**STATE OF ALASKA ITB NUMBER 25SWS0820B
AMENDMENT NUMBER TWO**

DATE AMENDMENT ISSUED: February 2, 2026

ITB TITLE: Palmer Courthouse Bi-Directional Amplifier

PALMER
COURTHOUSE
BASEMENT
PLAN

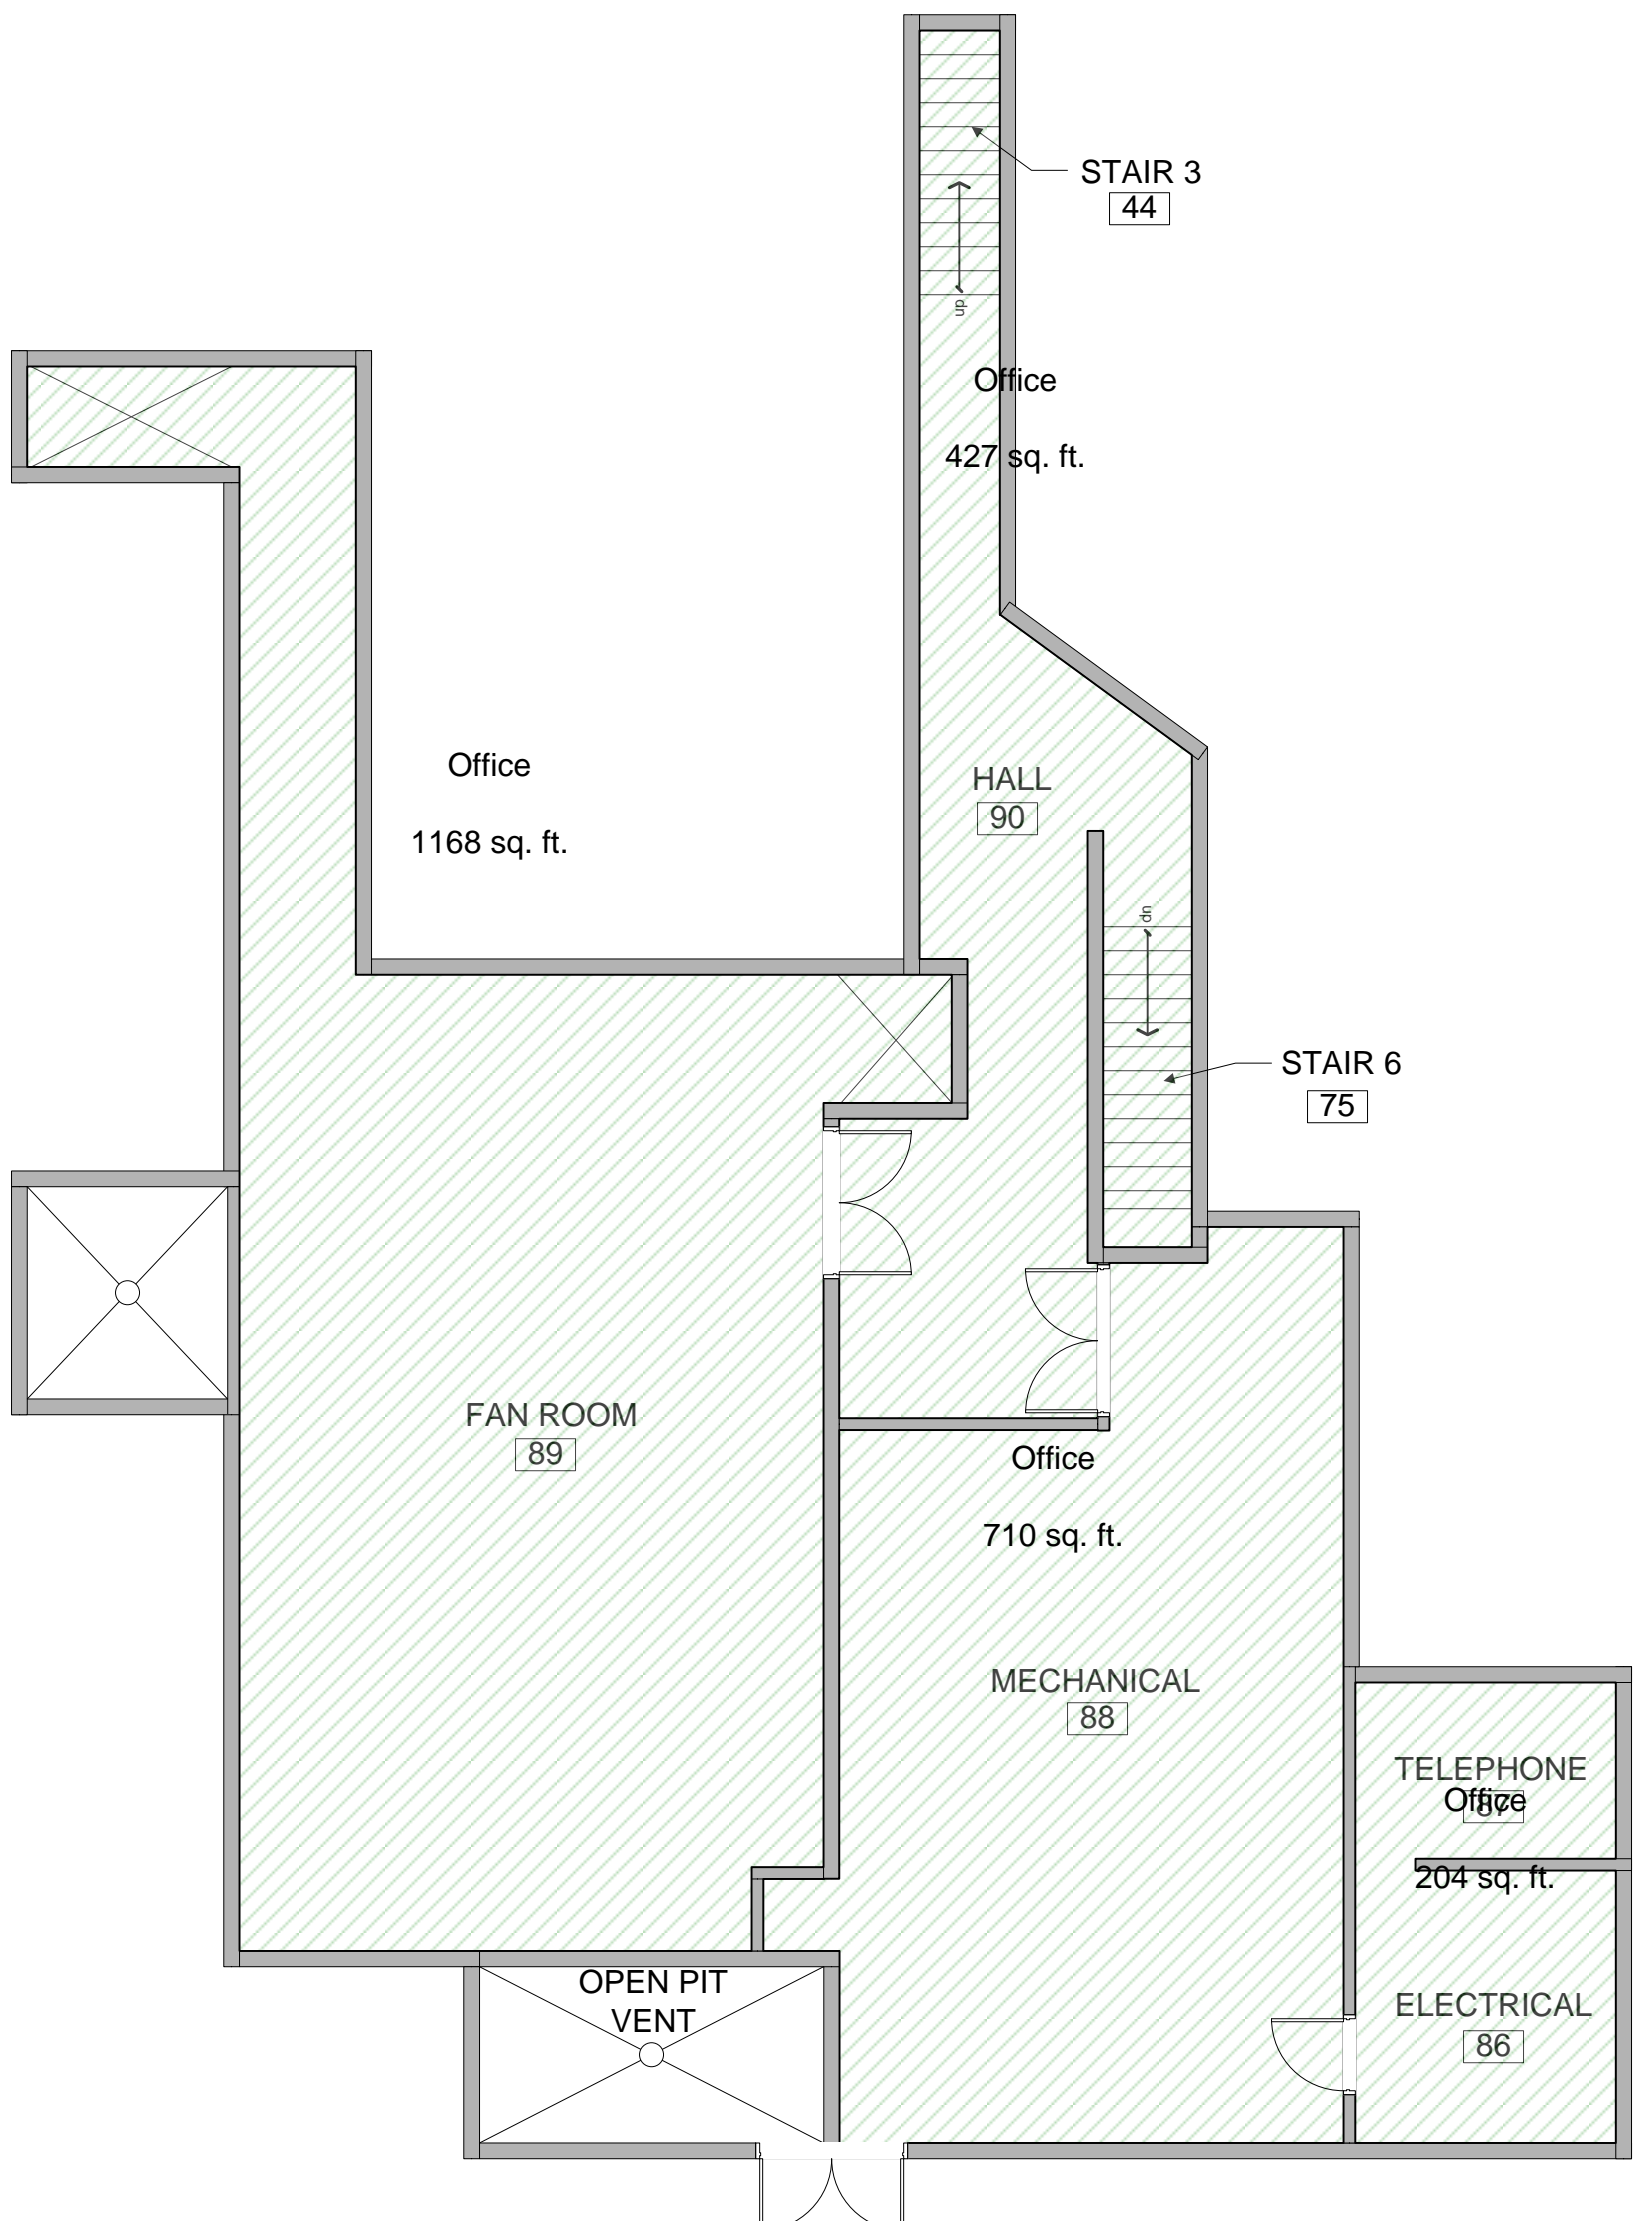
Question 3: Our Engineers reviewed this updated floor plan, but it seems to be missing the basement, the lot/penthouse, and the roof. Can those please be included?

Answer: The only additional drawing available in electronic form is for the basement (attached).
